Access Compliance Report

Public Rights-of-Way

(Curb Ramps)

Intersection ID: 46492	Main Street: SHOPTON_RD_WEST	Cross Street: CASTLECOVE_RD	Location: E
ADA ID: C8F849C6736D	Ramp Type: PerpDiag	Initial Pass/Fail: Fail	Overall Compliance: No
Severity Score: 22.5			
Codes/Mitigation Info/Possible Solution		Field Measurements/Component Compliance

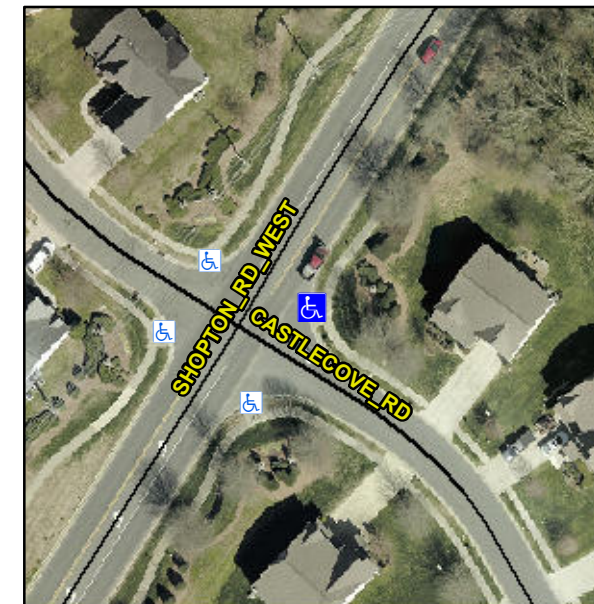
Not Found, R304.5.1, R304.2.2, R304.5.3

Compliance	Description	Data	Compliance	Description	Data
N/A	Ramp Length (in)	60.0	No	Ramp Slope (%)	8.4
No	Ramp Width (in)	47.0	No	Ramp XSlope (%)	2.8
N/A	Flare Type LT	N/A	N/A	Flare Type RT	N/A
N/A	Flare Slope LT (%)	N/A	N/A	Flare Slope RT (%)	N/A
N/A	Flare Traversable LT?	N/A	N/A	Flare Traversable RT?	N/A
N/A	Landing Length (in)	N/A	N/A	DWS Provided?	N/A
N/A	Landing Width (in)	N/A	N/A	DWS Contrast?	N/A
N/A	Landing Slope (%)	N/A	N/A	DWS Length (in)	N/A
N/A	Landing X Slope (%)	N/A	N/A	DWS Full Width?	N/A
N/A	Landing Curb? (Y/N)	N/A	N/A	DWS Offset (in)	N/A
N/A	Shared Landing?	N/A			
N/A	Gutter Ponding?	N/A	N/A	Gutter Slope (%)	N/A
N/A	Gutter Lip Ht (in)	N/A	N/A	Gutter X Slope (%)	N/A
N/A	Painted X Walk1?	No	N/A	Painted X Walk2?	No
	X Walk 1 Direction	To NW		X Walk 2 Direction	To SW
N/A	X Walk 1 Width (in)	N/A	N/A	X Walk 2 Width (in)	N/A
	X Walk 1 Slope (%)	3.8		X Walk 2 Slope (%)	1.8
	X Walk 1 X Slope (%)	0.3		X Walk 2 X Slope (%)	2.0

Remove & Replace Curb Ramp With Two New Directional Ramps or Equivalent.
